| United States Nuclear Regulatory Commission Official Hearing Exhibit | In the Matter of: NUCLEAR INNOVATION NORTH AMERICA LLC (South Texas Project Units 3 and 4) |

Combined License Application Review STP Units 3 and 4

Safety Panel 1
November 19, 2015

Tier 1 Departure On I&C Architecture

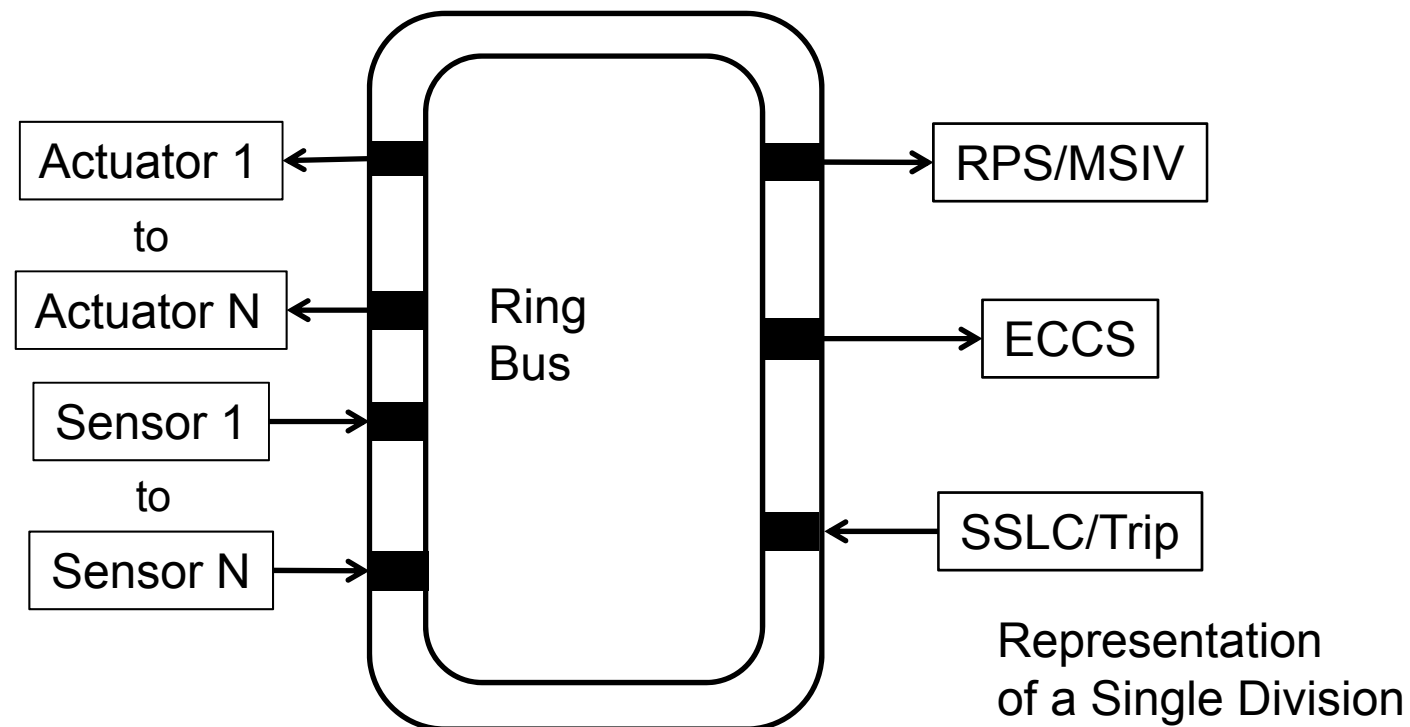
- **Diverse digital platforms are used for the Engineered Safety Features System and the Reactor Trip System**
- **Changes enhance protection against failures**

Certified U.S. ABWR Ring Bus Design

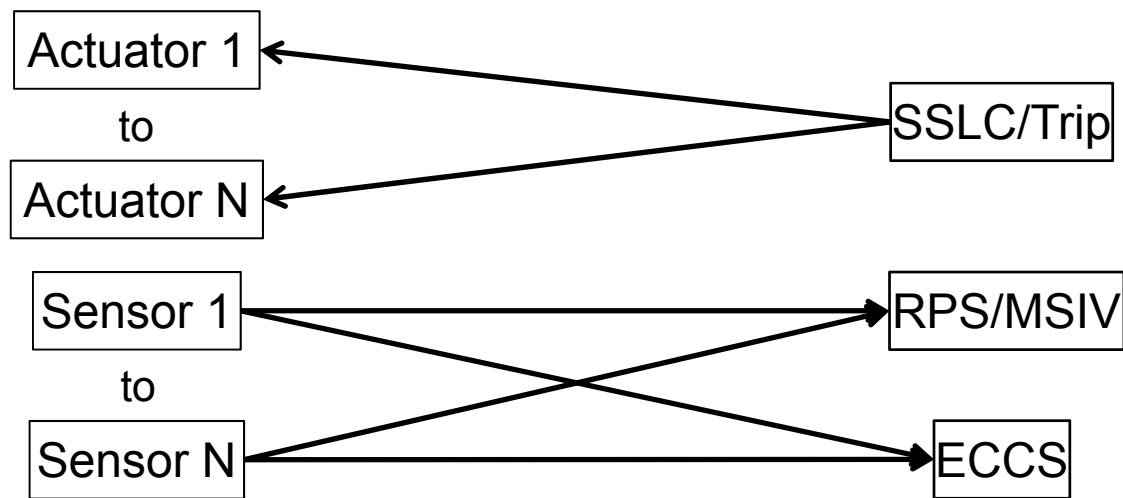
- **Selection of digital instrumentation and control (I&C) platforms resulted in changes to I&C architecture**
- **Data communication design changed the most**
